# North West Coast Connections – Consultation on the project’s Initial Needs Case and suitability for tendering

## Consultation

**Publication date:** 14 December 2016

Figure 2: Indicative timeline based on NGET’s construction programme

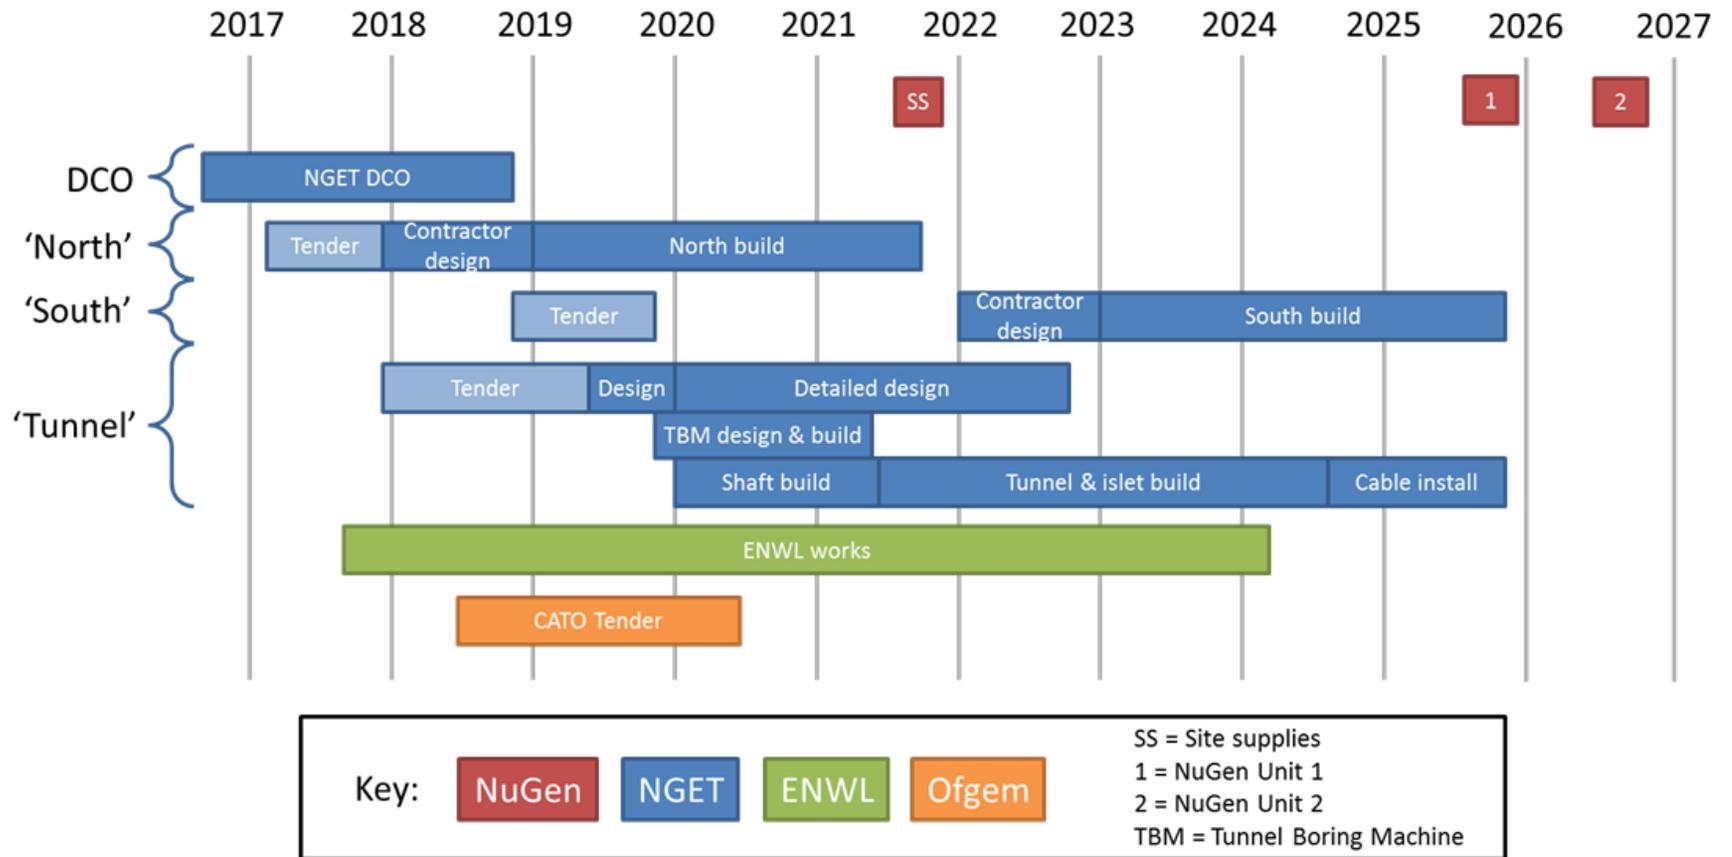
3.24. There would be around 1 year from CATO appointment until the August 2021 milestone date. Our current view is that a CATO may be unable to meet this first milestone, given our earliest CATO appointment date. This impacts on CATO deliverability of the northern section of the project (see ‘Packaging’). Given the recent modification application to move this milestone to August 2022 we will keep the assessment for this section under review. Based on early information we have received so far, our provisional view is that a CATO may still be unable to meet this milestone.

3.25. There would be around 5 years from CATO appointment until the August 2025 milestone date. During our assessment of the Initial Needs Case, NGET provided justification that the time required to procure, construct, and lay cable in the tunnel would be around 6-7 years. TNEI have considered NGET’s justification, and broadly agree with the timetable and evidence provided. If this is correct, then a CATO may be unable to deliver the tunnel on time, however we would like to understand industry views on the timeline for the tunnel.

**Figure 3: Simplified summary of options to re-package substation works (black lines are transmission lines, black boxes are substations, and the red lines are indicative division points)**

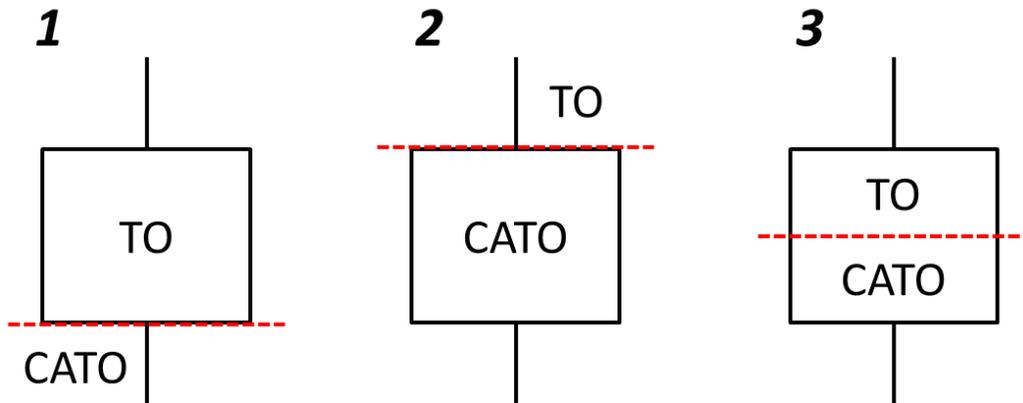
3.41. Our current view is that options 1 and 3 may be the most appropriate to consider if we were to tender the project. Their reliance on established codes, agreements, and industry ways of working could make them easier to implement and less administratively onerous than option 2, which would require transfer of existing assets to the CATO and include associated due diligence by bidders.
